Access Compliance Report

Public Rights-of-Way

Intersection ID: 10849	Main Street: FREEDOM_DR	Cross Street: PACIFIC_ST	Location: SE
ADA ID: 7C9A58801B66	Ramp Type: Perp	Initial Pass/Fail: Fail	Overall Compliance: No
		Severity Score: 10

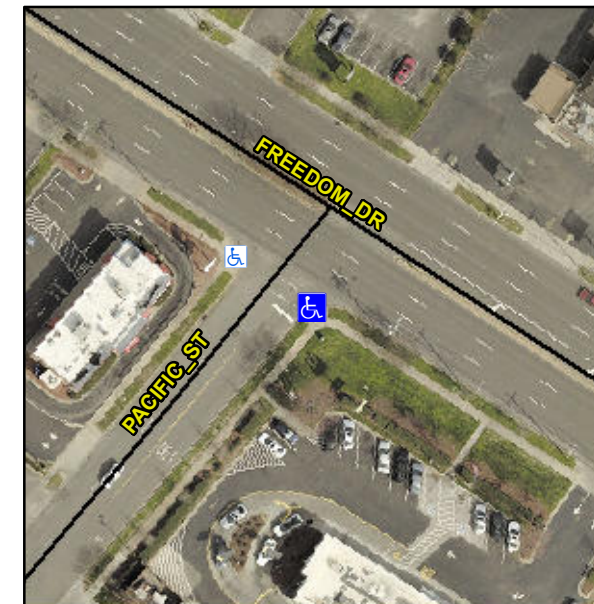
Not Found, R304.5.1, R304.5.3

Compliance	Description	Data	Compliance	Description	Data
N/A	Ramp Length (in)	61.5	Yes	Ramp Slope (%)	6.8
No	Ramp Width (in)	47.0	No	Ramp XSlope (%)	3.6
N/A	Flare Type LT	N/A	N/A	Flare Type RT	N/A
N/A	Flare Slope LT (%)	N/A	N/A	Flare Slope RT (%)	N/A
N/A	Flare Traversable LT?	N/A	N/A	Flare Traversable RT?	N/A
N/A	Landing Length (in)	N/A	N/A	DWS Provided?	N/A
N/A	Landing Width (in)	N/A	N/A	DWS Contrast?	N/A
N/A	Landing Slope (%)	N/A	N/A	DWS Length (in)	N/A
N/A	Landing X Slope (%)	N/A	N/A	DWS Full Width?	N/A
N/A	Landing Curb? (Y/N)	N/A	N/A	DWS Offset (in)	N/A
N/A	Shared Landing?	N/A			
N/A	Gutter Ponding?	N/A	N/A	Gutter Slope (%)	N/A
N/A	Gutter Lip Ht (in)	N/A	N/A	Gutter X Slope (%)	N/A
N/A	Painted X Walk1?	Yes	N/A	Painted X Walk2?	N/A
	X Walk 1 Direction	To NW		X Walk 2 Direction	N/A
N/A	X Walk 1 Width (in)	93.0	N/A	X Walk 2 Width (in)	N/A
	X Walk 1 Slope (%)	5.7		X Walk 2 Slope (%)	N/A
	X Walk 1 X Slope (%)	0.9		X Walk 2 X Slope (%)	N/A

Remove & Replace Entire Ramp.
